Docket Number:	08-AFC-04C
Project Title:	Orange Grove Energy Project - Compliance
TN #:	203142
Document Title:	Pala Band of Mission Indians c/o Walter Rusinek, Procopio Comments: Updated Comments of the Pala Band of Mission Indians on the Petition to Amend the California Energy Commission Decision for the Orange Grove Power Project (08-AFC-4C)
Description:	N/A
Filer:	System
Organization:	Pala Band of Mission Indians c/o Walter Rusinek, Procopio
Submitter Role:	Public
Submission Date:	10/1/2014 12:48:17 PM
Docketed Date:	10/1/2014

Updated Comments of the Pala Band of Mission Indians on the Petition to Amend the California Energy Commission Decision for the Orange Grove Power Project (08-AFC-4C)

Re: Petition to Amend the California Energy Commission Decision for the
Orange Grove Power Project (08-AFC-4C)

SAN DIEGO GAS & ELECTRIC SAN DIEGO, CALIFORNIA APPROXIMATE LOCATION OF EXISTING 6" PVC & STEEL WATERLINE FROM WELL TO HIGHWAY CROSSING	DRAWN BY: <i>RAP</i>	OK TO INSTALL:	DRAWING NO.:
	DATE: <i>12-19-97</i>	R/W OK:	COORDINATES
	SCALE: <i>NONE</i>	APP'D BY:

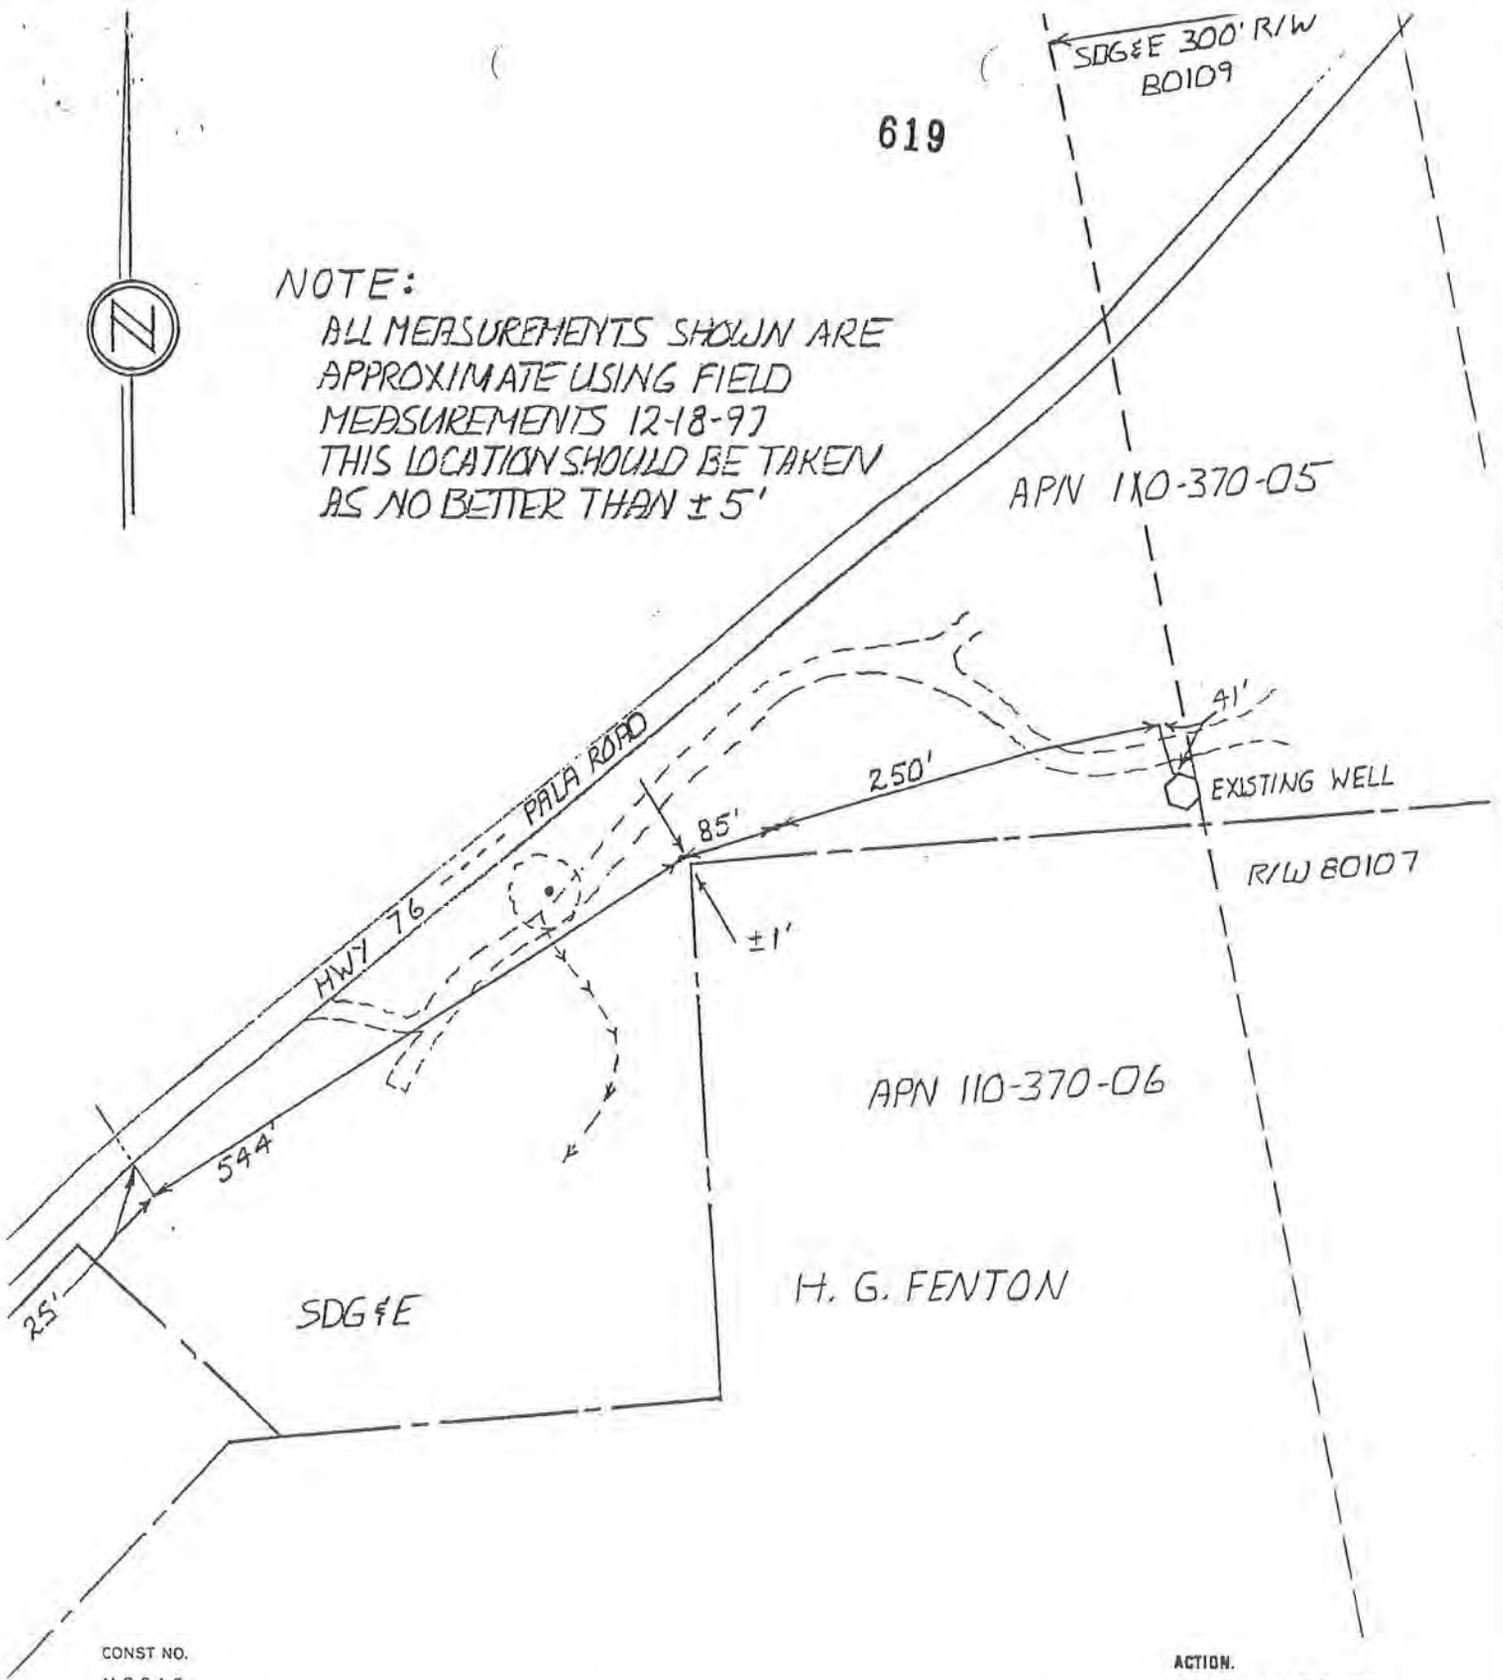
Exhibit C of the Easement shows the location of the six-foot wide easement for the well and the pipeline granted to SDGE. While the exhibit states that the measurements are “approximate,” if one compares the location of the pipeline shown on Exhibit C of the Easement with the location of the pipeline shown on Figure 3.1 of the Support Document it is not clear that these are in the same location. That raises questions about the claim in the Petition that the upgraded “pipeline would be routed to follow the existing pipeline route.” (Support Document at 13). Given the apparent discrepancy between the recorded Easement and the figure in the Petition, OGE must provide additional information showing that the new pipeline would be located within the six-foot wide easement identified in Exhibit C. Neither OGE nor SDGE has the right to install a new pipeline outside the granted easement.

Figure 6.5-4
 100-Year Flood Zone
 Orange Grove Project
 San Diego County, CA

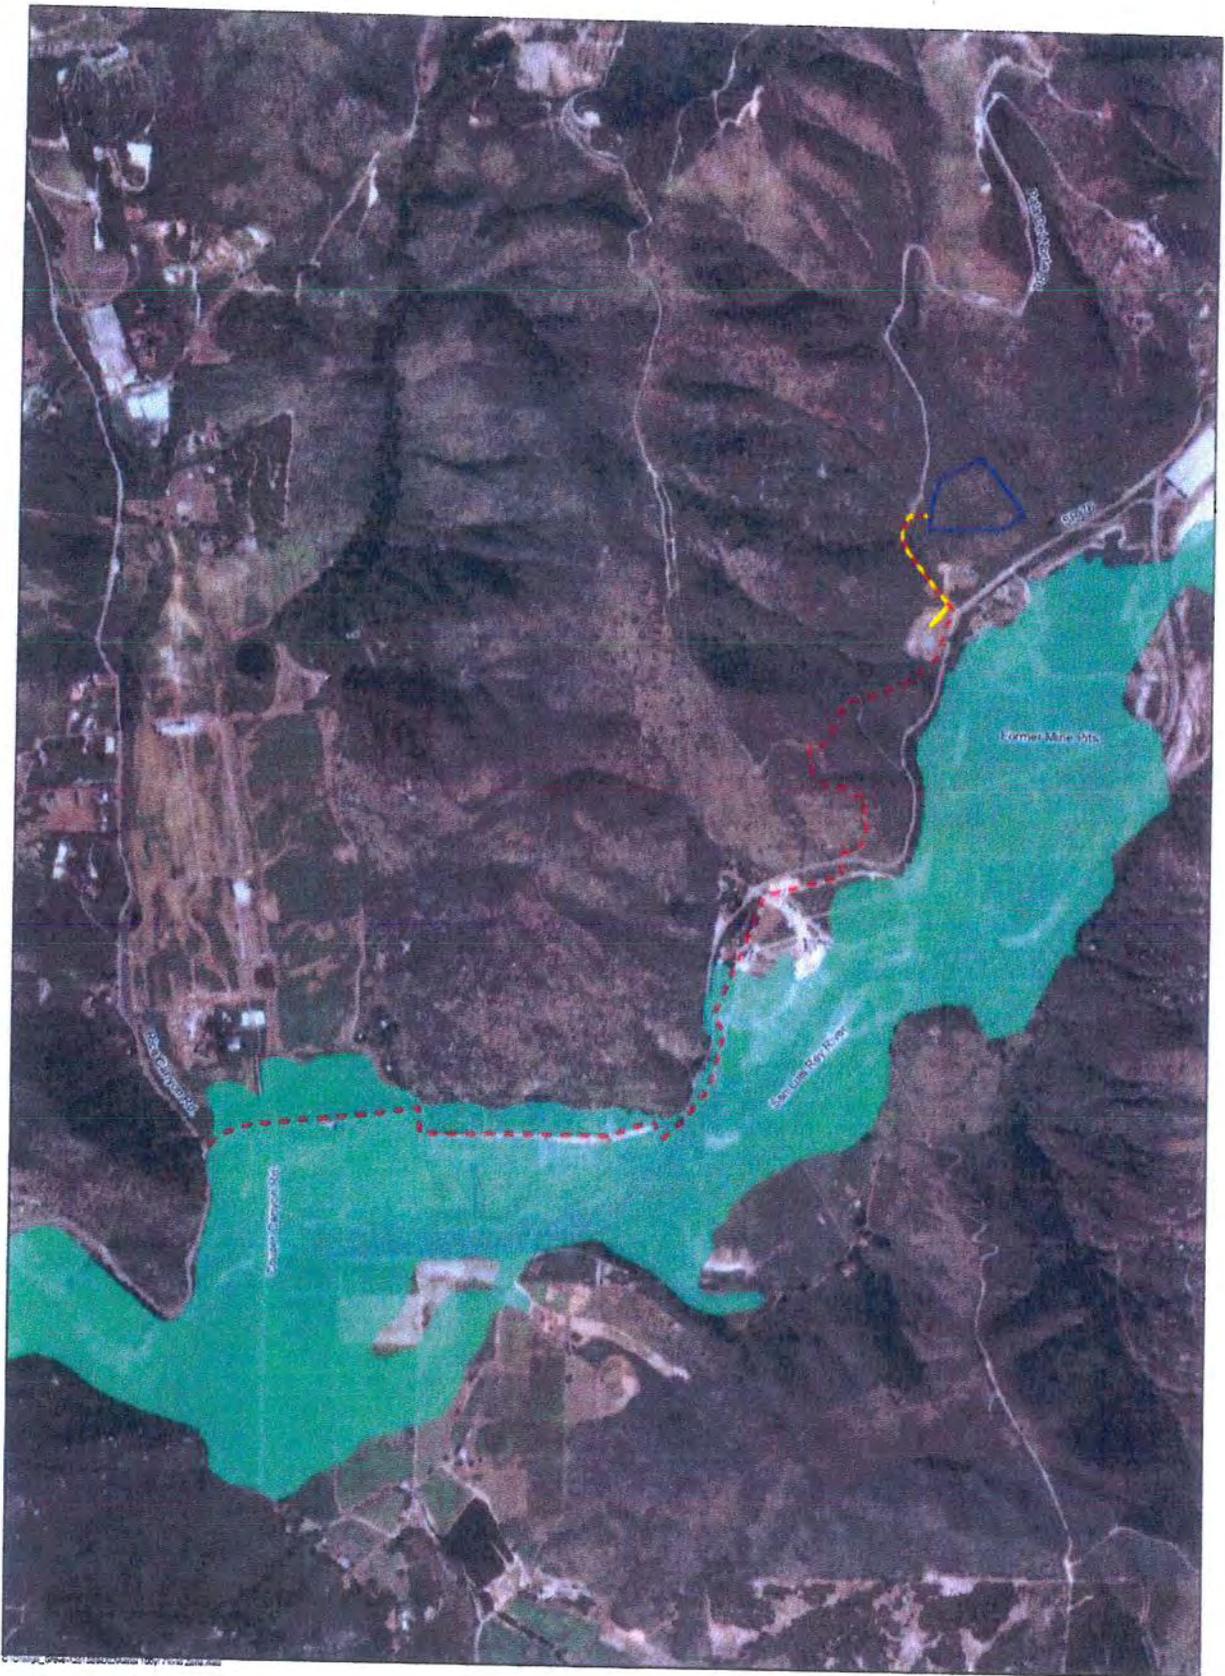
For example, Figure 6.5-4 of the Application showed that the Power Plant Parcel is not within the 100-year flood zone, which the figure shows is located entirely south of SR 76 on the Pala Property. (Exhibit K). That is evidence that the Power Plant Parcel is not riparian to the surface flow of the San Luis Rey River and that even in very high flows, water from the river does not touch the Power Plant Parcel.

FIGURE 6.5-5

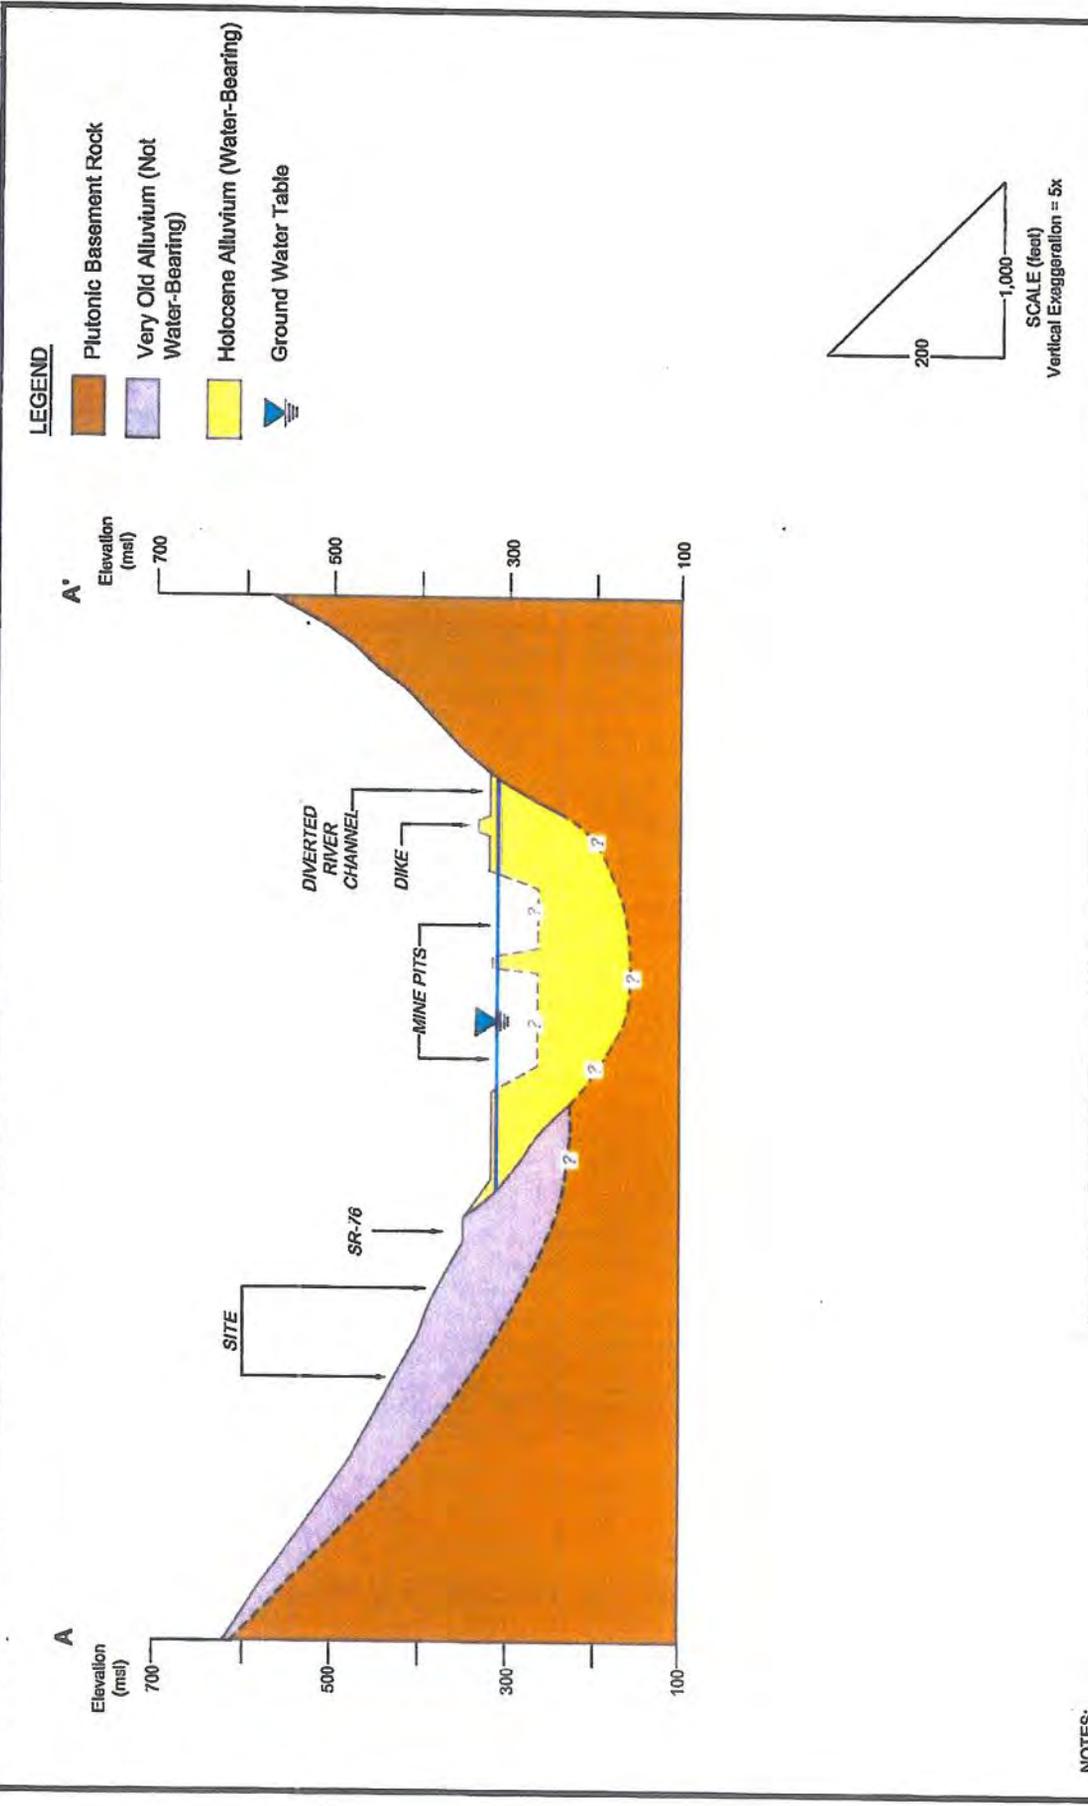
As to the subterranean stream, Figure 6.5-5 of the Application provides a hydrogeologic cross-section of the area where the Pala Property and the Power Plant Parcel are located. (Exhibit L). The location of the cross-section included in Figure 6.5-5 is identified on Figure 6.5-2 of the Application, which is also included in Exhibit L. Figure 6.5-2 shows that the cross-section depicted on Figure 6.5-5 runs through the Pala Property and directly across the area where the Power Plant is located.

The cross-section reflected in Figure 6.5-5 shows the subterranean stream (the Pala Basin alluvium) in a gold color, which the figure identifies as the "water-Bearing"

alluvium. Figure 6.5-5 also shows that the “water-Bearing” alluvium is located entirely on the south side of SR 76. Conversely, the Power Plant Parcel (identified as the “Site” on the graphic) is shown to be underlain by “Very Old Alluvium” that is “Not Water-Bearing.” Both areas are underlain by the “Plutonic Basement Rock.”

The conclusions stated in the Application and shown graphically on Figure 6.5-5 that the subterranean stream does not abut the Power Plant Parcel were confirmed by the installation of a test well on the Power Plant Parcel in September of 2013 by TRC Solutions (“TRC”). TRC also had prepared the Application, other certification documents, and the Figures discussed above. The test well was installed to a depth of approximately 75 feet below ground surface (“bgs”) on the edge of the Power Plant Parcel close to SR 76. (Exhibit M at 1, Figure 2).

The TRC report also included a boring log of the test well in Appendix C. That boring log shows that “large broken igneous cobbles” were encountered at a depth of about eight feet bgs and that “highly weathered igneous rock” was encountered at 20 feet bgs and below, including in the area where the groundwater was encountered. This data further confirms the conclusions of the hydrogeologic cross-section in Figure 6.5-5 of the Application.

The TRC test well confirmed what Figure 6.5-5 shows: the Power Plant Parcel does not abut the subterranean stream. As a result, SDGE as the owner of the Power Plant Parcel does not have the right as a riparian owner to divert water from the SDGE well for use on that parcel. Instead, SDGE or OGE must obtain an appropriative rights permit from the State Board in order to divert water from the SDGE well for use on the Power Plant Parcel. That this issue was not addressed in the Petition is a fatal flaw in the analysis.
